RE: PZ# 24-12000027 Vera Site Plan ([494212000070](#))

The above-referenced Site Plan application has been reviewed by the Development Review Committee and discussed at the April 16<sup>th</sup>, 2025 DRC Meeting. Comments are being addressed and resolved with each discipline reviewer, though one outstanding comment is related to a necessary zoning code modification/waiver that would otherwise result in a development conflict with the City's CPTED guidelines as well as adjacent property conditions. We would like to take the opportunity to justify the need for Director modification/waiver in accordance with code sections 155.5203.F.2.e [Perimeter Buffers; Applicability].

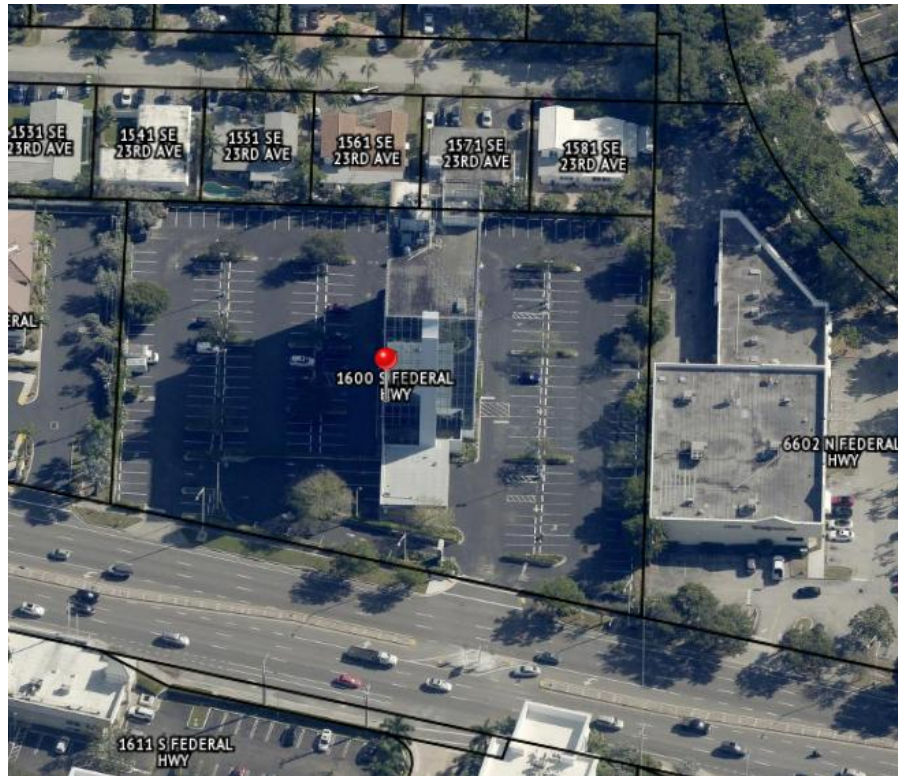
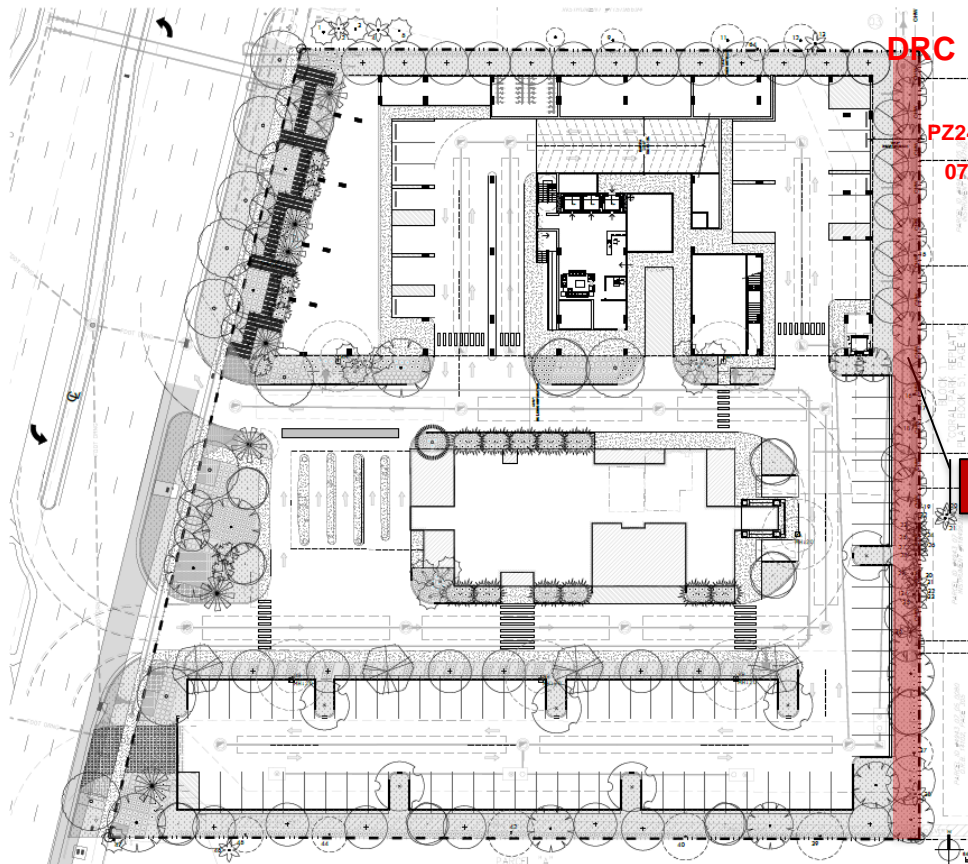
**URBAN FORESTRY comment 7** states, "Please be aware that the required Type B buffer fence location as proposed will require a CPTED waiver signed by the DSD." **DRC**

As shown below, the property abuts multifamily residential zoning to the east where a Type B buffer is required per Table 155.5203.F.3. For the safety and privacy of the residential properties, we request all buffer landscaping to be installed inside of the wall, rather than placing the wall in the middle of the 10 foot-buffer. If a wall is placed in the middle of the buffer, maintenance of the landscaping and wall will be necessary, thereby possibly facilitating a maintenance worker to trespass onto residential private property. If the residential properties include a fence or wall on their private property, an additional wall will create an "alley" of unmaintained area that invites trespassing and possibly illegal activities. Providing the fence in the middle of the east buffer would put a maintenance worker near the railroad tracks which creates an unsafe condition for the maintenance worker.

As mentioned, requiring the buffer barriers in the middle of the 10-foot buffer not only violate the city's CPTED guidelines for Natural Surveillance but poses a safety risk for maintenance due to adjacent property conditions. Below is a summary of the buffer modifications/waivers we are requesting, with a diagram for these:

Buffer	Barrier Material	Barrier Location
East Type B	Solid fence, no waiver requested	Exterior boundary of buffer, rather than middle
